Subject: Submittal of Response to Comments Final Additional DNAPL
Recovery Well Installation and Testing Work Plan
Detrex Source Control Area – Fields Brook Superfund Site
Detrex Corporation, Ashtabula, Ohio
Docket No. V-W-98-C-450

**DETREX CORPORATION RESPONSE TO UNITED STATES ENVIRONMENTAL
PROTECTION AGENCY COMMENTS ON THE ADDITIONAL DNAPL RECOVERY
WELL INSTALLATION AND TESTING WORK PLAN
URS CORPORATION**

Figure 1
Detrex New Recovery GP & MP Locations
 Detrex Corporation, Ashtabula, Ohio
 URS Corporation

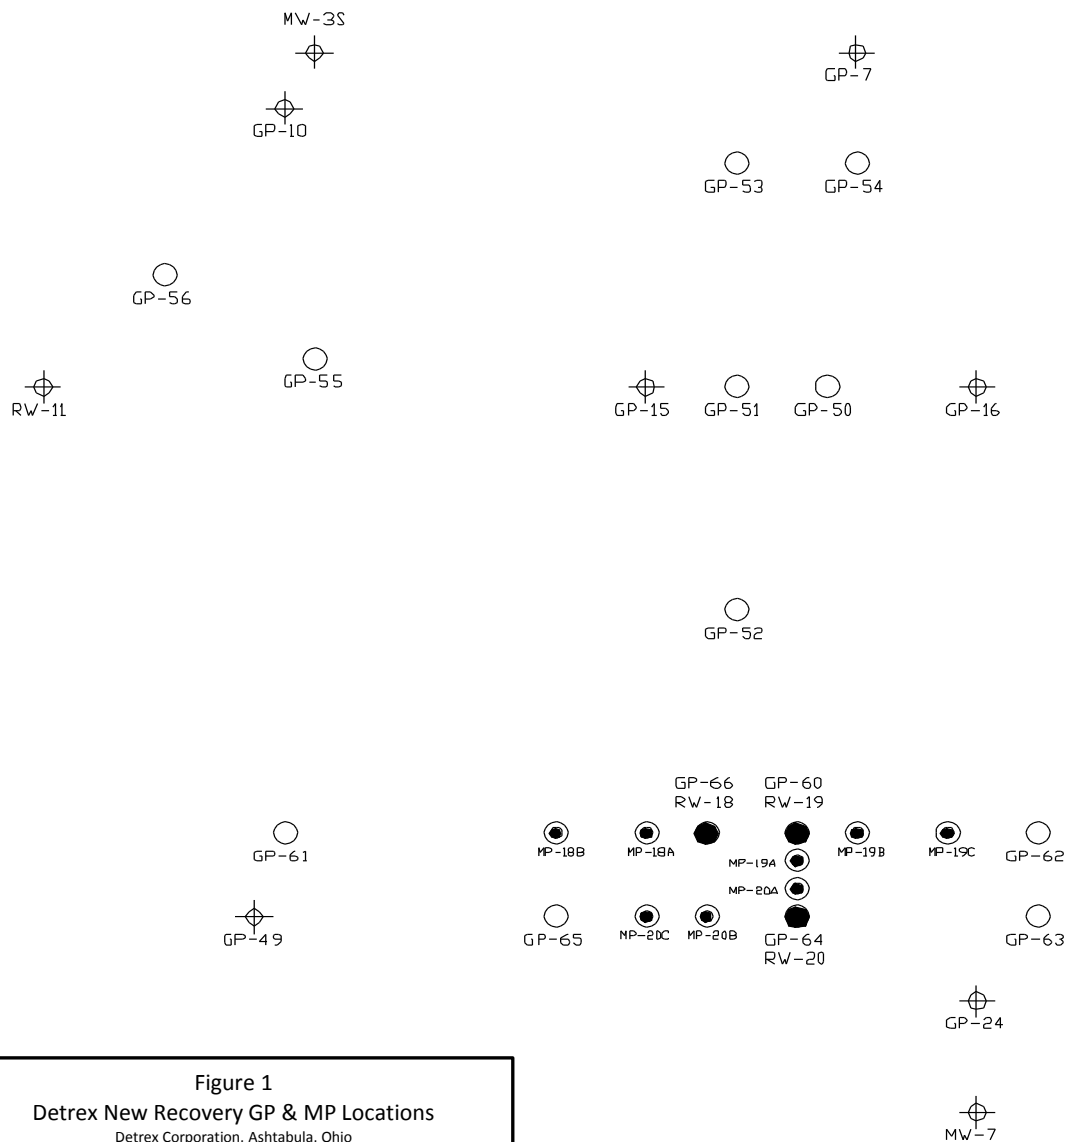
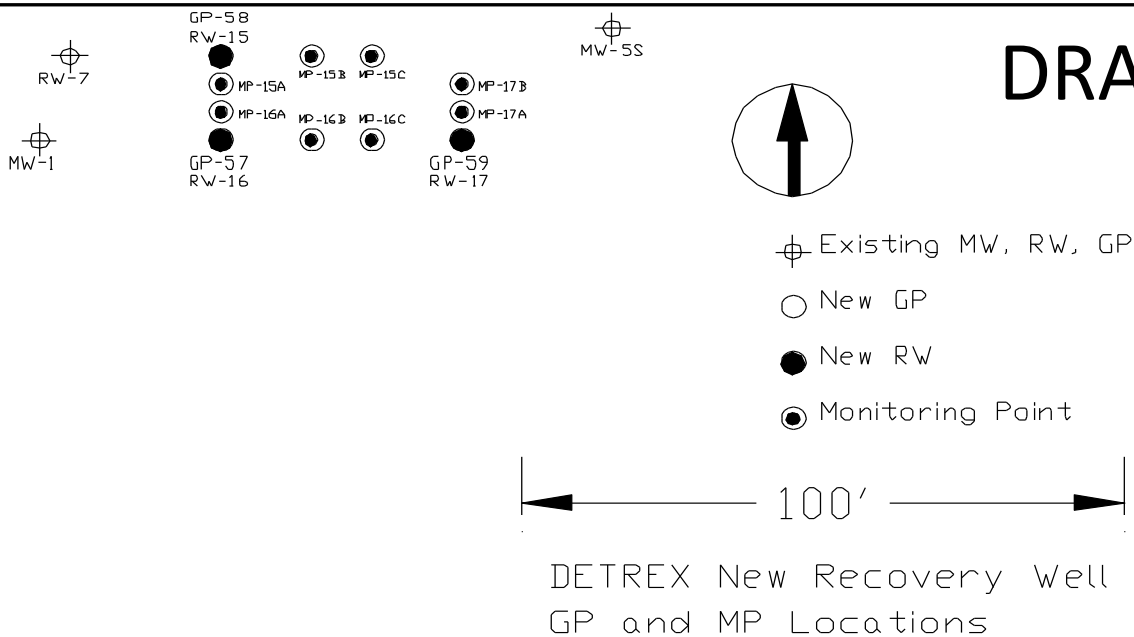
The general locations for the additional well testing shown in Figure 2-2 are acceptable. The general area for the recovery wells includes an area located outside the lagoon boundaries. However, based on best available information, it is recommended that the location of each recovery well for the lagoon area be within the limits of a former lagoon.

Detrex agrees with this comment. During the geoprobe work completed on October 10 through 12, 2012 to identify recovery well locations, both U.S. EPA and Ohio EPA were present during this field work. Results from the geoprobe work indicated that the proposed testing areas were modified slightly both within the lagoon area and outside. The attached figure provides the location of the six (6) recovery wells that will be drilled on the site. The figure also shows proposed monitoring points. Also during the field work, the depth and length of the recovery well screens were agreed to.
